CNL-16-145

Browns Ferry Nuclear Plant, Units 1, 2, and 3  
Renewed Facility Operating License Nos. DPR-33, DPR-52, and DPR-68  
NRC Docket Nos. 50-259, 50-260, and 50-296

Subject: **Proposed Technical Specifications (TS) Change TS-505 - Request for License Amendments - Extended Power Uprate (EPU) - Supplement 30, Revised Responses to Requests for Additional Information**

**ENCLOSURE 2**  
**Revised Responses to NRC Requests for Additional Information**  
**EMCB RAIs 21, 25, 38, 39, and 43**

**Figure 38c-1 (Figure I-9.2.2) Design Feature Curves for Austenitic Steels, Nickel-Chromium-Iron Alloy, Nickel-Iron-Chromium Alloy, and Nickel-Copper Alloy for  $S_a \leq 28.2$  ksi, for Temperatures Not Exceeding 800°F (For  $S_a > 28.2$  ksi, use Figure I-9.2.1)**

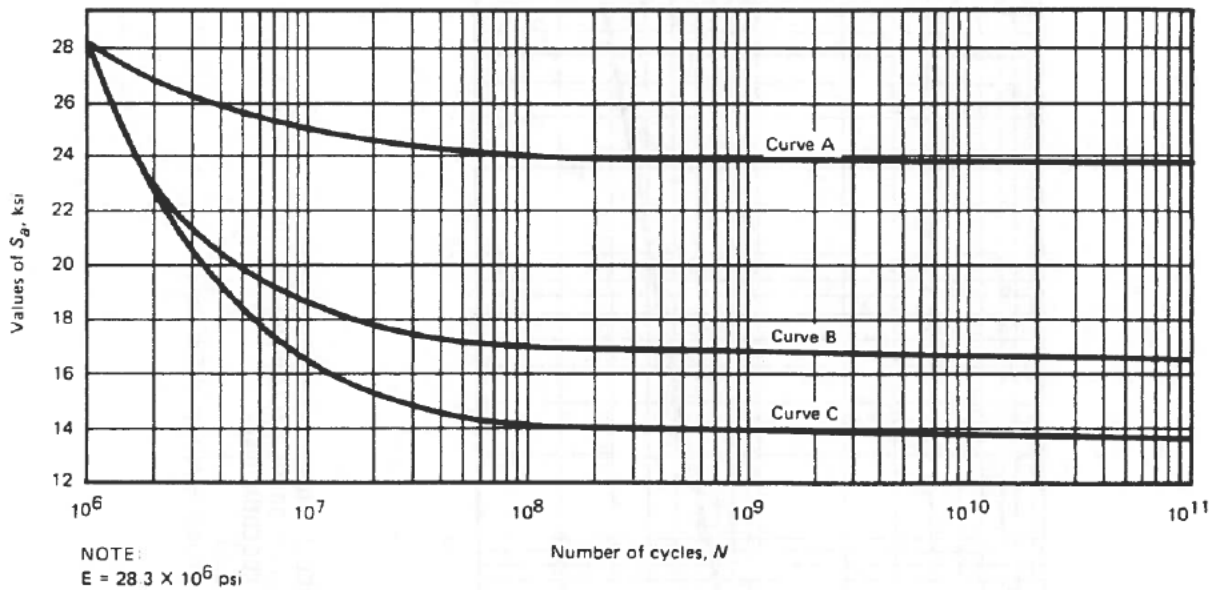
- c. SGs 6 and 9 have very high potential strains – up to [[ ]]. SGs have a finite life, particularly at high amplitude. Provide information on which frequency(s) contribute most strongly to the strain at these gage locations. Describe the survivability (expected life or number of cycles) of the dryer SGs at these potential strain amplitudes.

The use of the Ni-Cr-Fe fatigue Curve C (Figure 38c-1) from the American Society of Mechanical Engineers (ASME) Section III (Division 1, Appendix I, 1995) for the fatigue evaluation on the strain gage product (with the wire made of Ni-CrV) is considered conservative.

**Figure 39-2. Typical Responses of One-Degree Elastic Systems (Un-damped) Subjected to Symmetrical Triangular Load Pulse (T is the natural period of the system)**

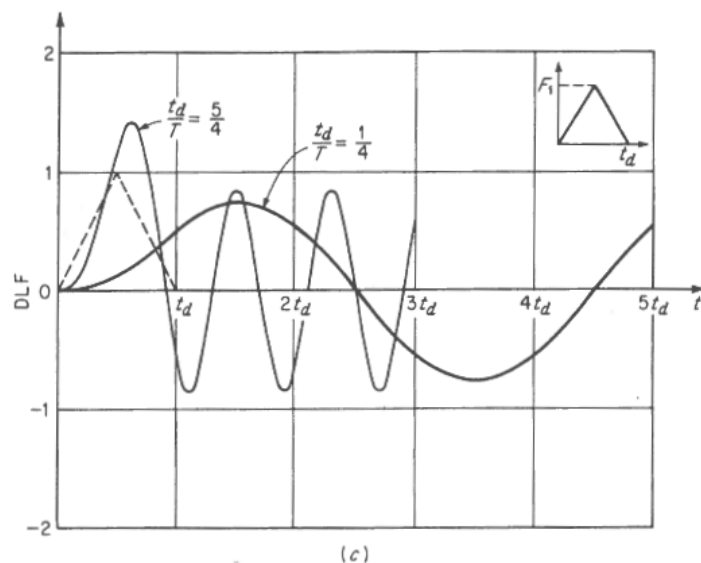
- a. Table 8.1-4 of Appendix-A (p. A-88 of Reference 8) states that a [[  
]]. Provide the numerical value of the [[  
]] used in the static analysis. Also, provide a justification for the magnitude of the [[  
]] value.

Figure 39-1 shows an example of the typical time histories for several points on the dryer hood. The time history at each location on the dryer hood can be obtained from the corresponding time history as shown in Figure 39-1. The acoustic loads applied on the steam dryer outer hood for the MSLB are obtained by applying the dynamic effect from the MSLB transient event. To account for the dynamic effect from the MSLB transient event, this factor is defined as follows. Because deflection, spring forces, and stresses in the linear elastic structure analysis are all proportional, the response of the system is proportional to the input. In Reference 39-1 the responses for one-degree elastic systems (un-damped) subjected to symmetrical triangular load pulse are calculated. Figure 39-2 (Figure 2.6(c) in Reference 39-1) shows the typical responses for this type of forcing function which start at zero and reach a maximum  $F_1$  at one-half the total force duration  $t_d$ , with  $T$  as the natural period of the system. The maximum response as a function of  $t_d/T$  is given by Figure 39-3 (Figure 2.8(a) in Reference 39-1). As shown in Figure 39-1, the time histories of MSLB acoustic loads

**Figure 43-1 Finite Element Model Description for Test Case VM39 with Vertical Force Applied**

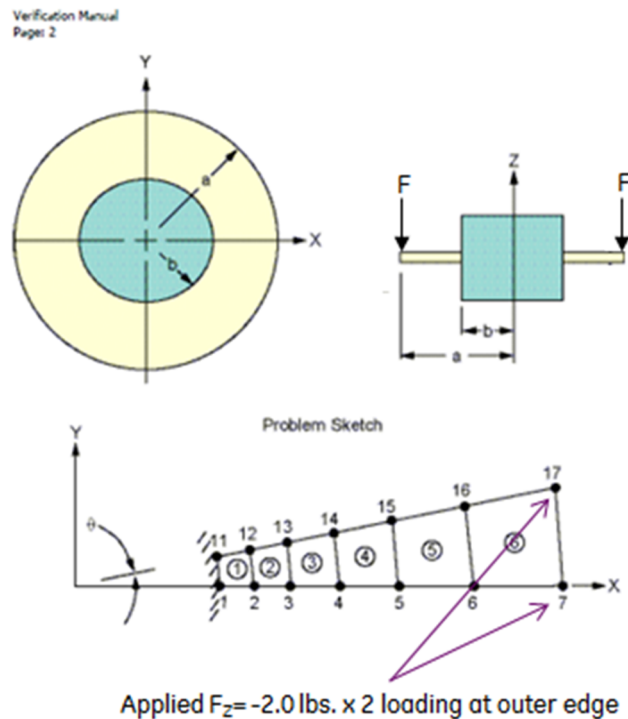
Provide a quantitative justification that ANSYS shell elements used to model the steam dryer in the finite element structural analysis of the steam dryer adequately capture peak stresses.

To determine the consequence of the transverse shear assumption in the ANSYS element formulation for the three element types, SHELL181, SHELL63, and SHELL43, a simplified study using the ANSYS verification manual test case VM39 (Reference 43-1) was performed. This test case uses a 10° sector of a circular plate with a center hole to study the differences between the three element types (see Figure 43-1). The plate thickness for the study is 0.25 inches and the inner (b) and outer (a) radii are 10 inches and 30 inches, respectively. For the material, the elastic modulus is 30 MSI and Poisson's ratio is 0.3. Symmetric boundary condition configurations are applied along the two radial edges with the inner diameter constrained in all six degrees of freedom. In order to test the transverse shear effect, the loading is modified as a total 4 lb. vertical force applied evenly at outer edge two nodes (Nodes 7 and 17) of the 10° sector as shown in Figure 43-1. This simplified test case configuration is similar to the [[ ]].

It should be noted that the model used to compare SHELL181, SHELL63 and SHELL43 for the EMCB-RAI-43 response includes a stress concentration. As shown in Figure 43-1 and described in the RAI response, the test case is a 10° sector of a circular plate with a center hole. The nodes along the inner diameter of the plate are constrained in all six degrees of freedom. The 4 lb. vertical force is applied at the outer edge nodes. Similar to a cantilever beam, the higher stresses occur at the element closer to the fixed boundaries. In Table 43-1, the element component stress in X direction (SX) in Element #1 is much higher than the SX stress in Element #6, which clearly shows the stress concentration at the inner edge which is the discontinuity location. This test case configuration is similar to the base plate-to-mid support ring connection in the BFN replacement steam dryer FEM. Therefore, the results from this case study are considered to be adequate and there is no need to perform additional studies.
